LIGO E-TRAVELER

E-Traveler DCC Number & Revision D080251-00-C	Schematic DCC Number & Revision D020241 / D030452	Board Title ISS Intensity Stabilization Servo / ISS Photodiode	Board Serial Number 112
PCB Revision Rev D	Cognizant Design Engineer (COG) Ben Abbott	E-Traveler Originator & Institution Stefan Ballmer	Date May 2, 2008

A0 = -1
2 p @ 1.06 Hz

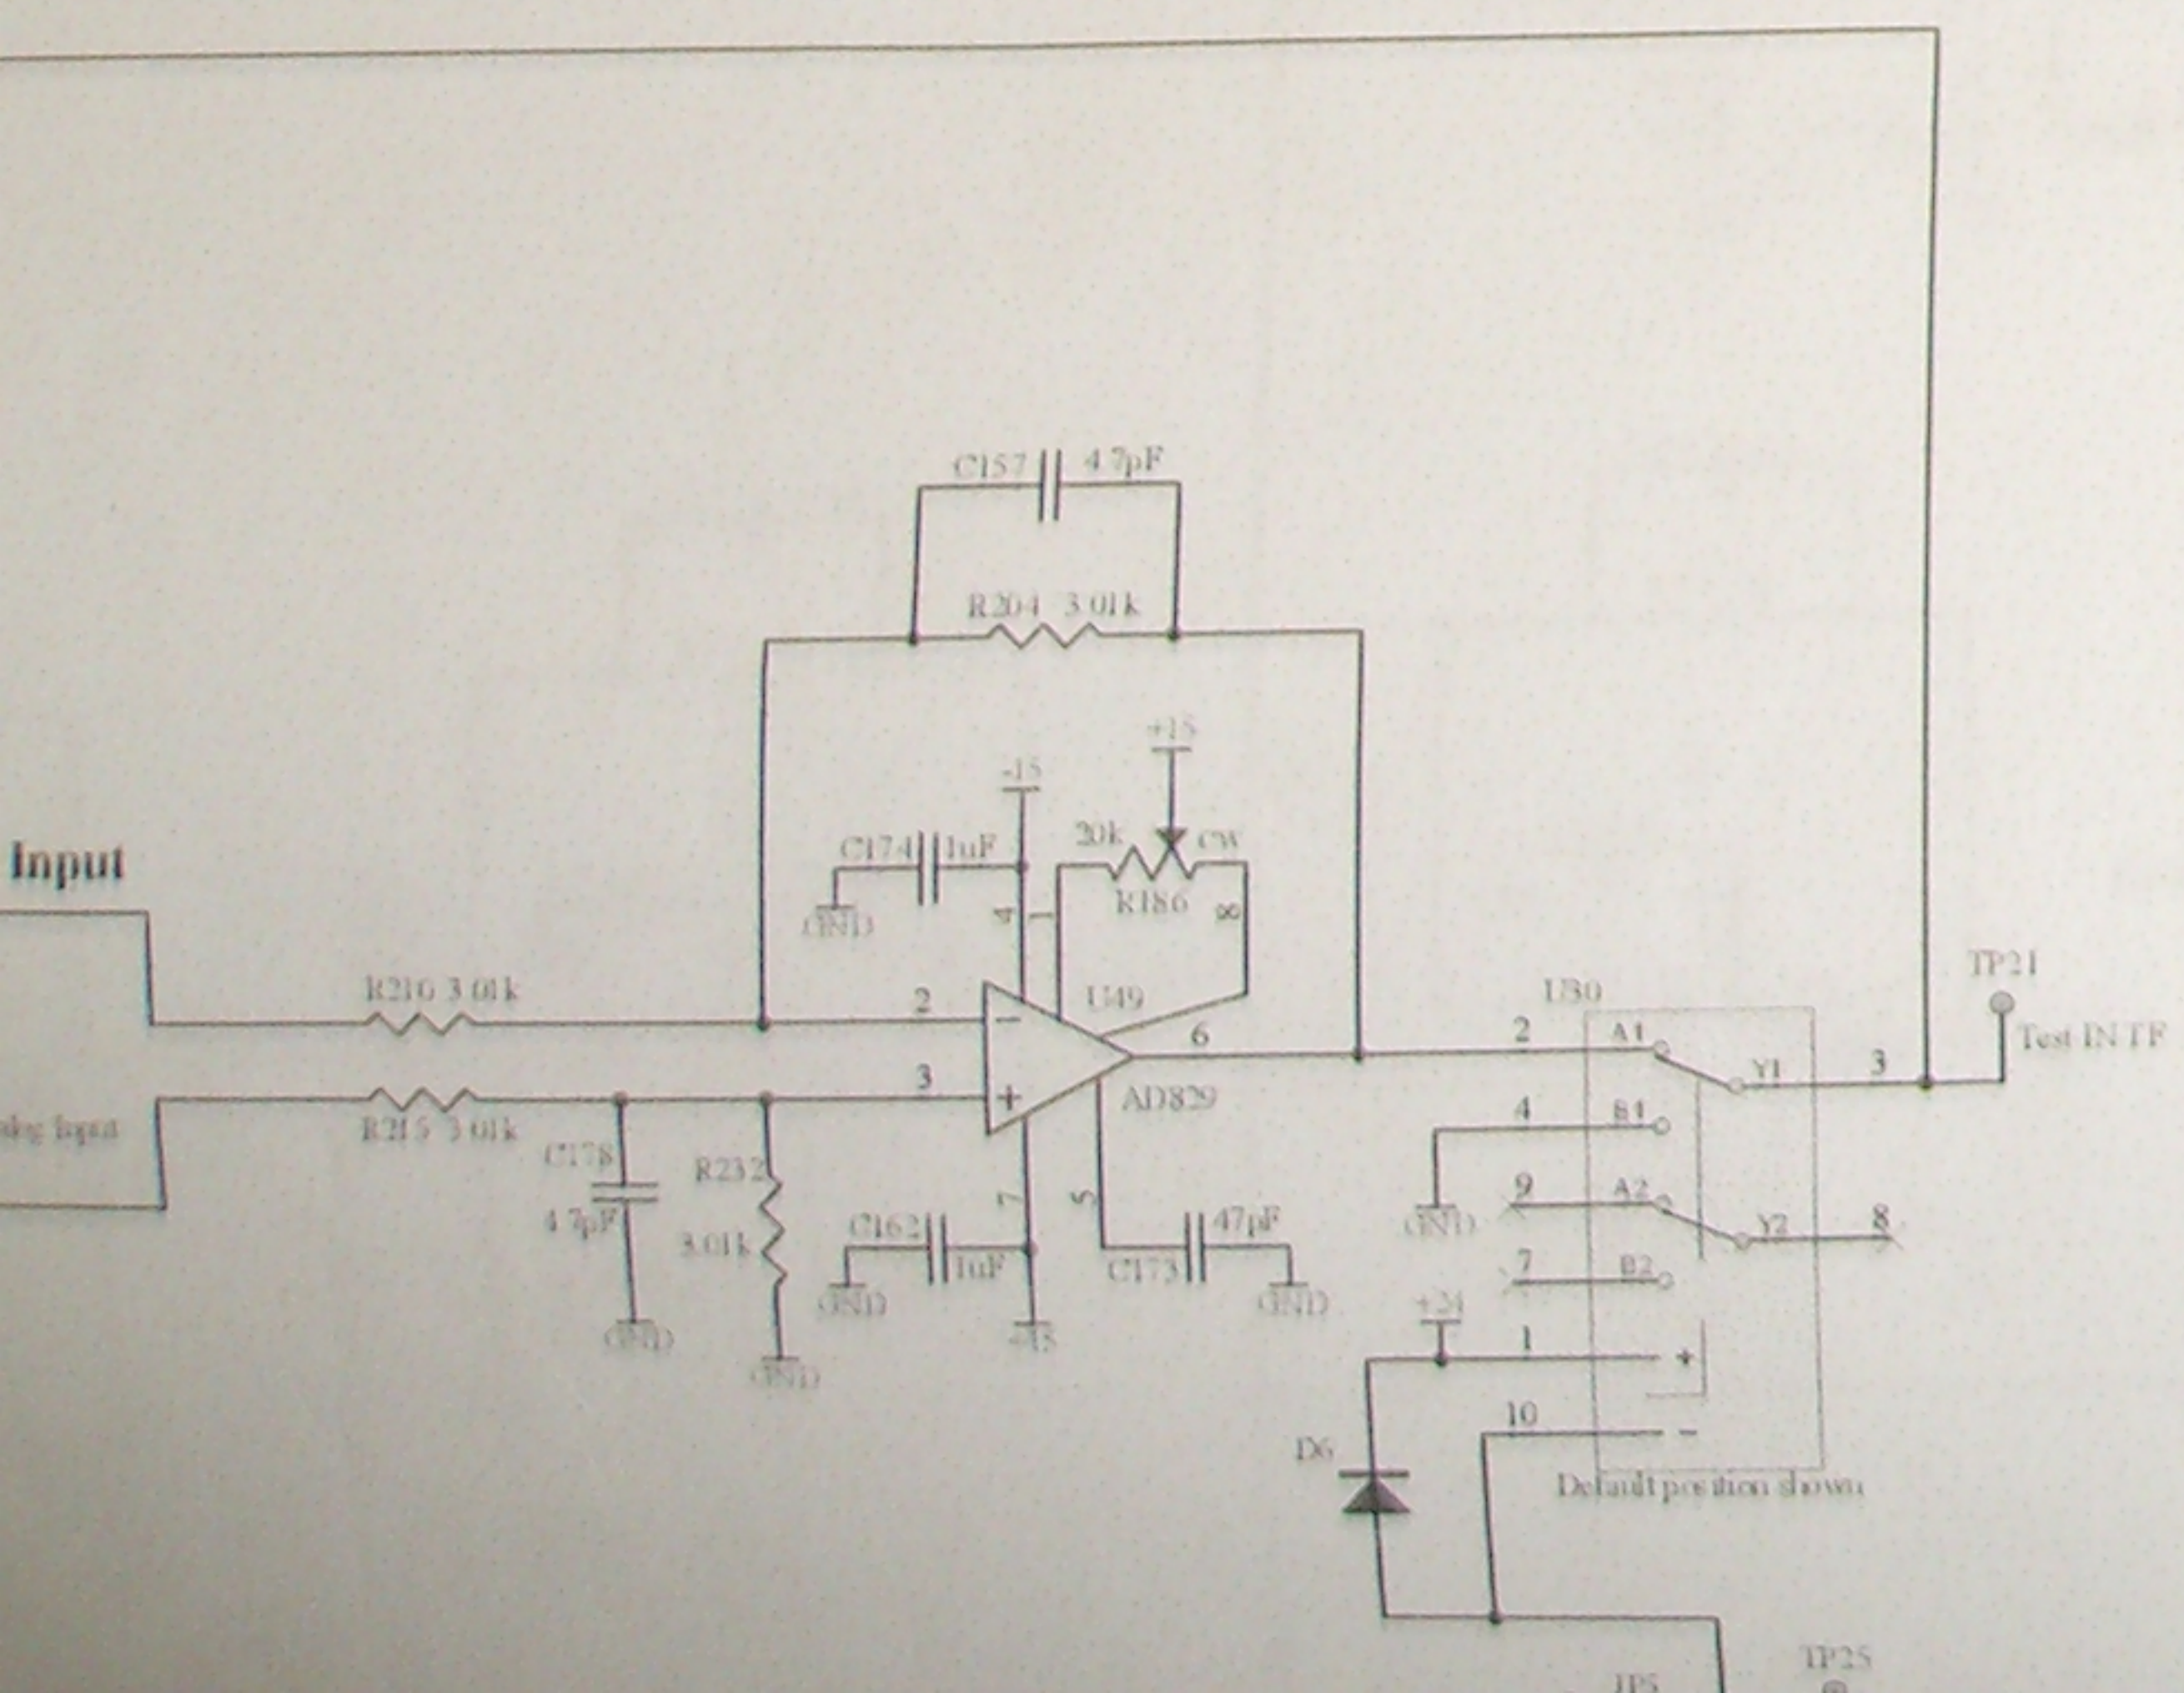
Switched U6, U54, U20, U64 to THS4131.
 Additional 2.1 kHz pole: Added C=150nF in parallel to R31 (499Ohm)
 Lower AC coupling pole by 2: C25 --> 2 uF
 Move pole:zero pair to 10x lower frequency (30Hz:0.8Hz): C2 --> 10 uF
 Add 20Hz:2Hz pole:zero pair: C1 --> 47 uF, R1 --> 169 Ohm, (R21 stays at 1.54k)
 Add 870Hz:8.6kHz pole:zero pair: C51 --> 330 nF, R51 --> 56.2 Ohm, (R58 stays at 499 Ohm)

By-pass U22 and add passive offset network at the output (see picture below). This gives an offset adjust between 0.44 V and 0.64 V.
 TP13 --- 422 Ohm ---x--- 0 to 500 Ohm --- 1 kOhm --- +15V --- 4.7uF --- GND
 |
 ----- to 50 Ohm load (AOM driver)

ISS photodiode (SN 123,124,132,134)
 - Added 10uF in parallel to C4 (total C4=11 uF)
 - Added 100 Ohm resistor in sensing ground line & R3 to 100 Ohm / Ccomp=68pF

$R82 = 422 \Omega$
to laser head

2.1 kHz pole

150 nF

20 Hz
2 Hz
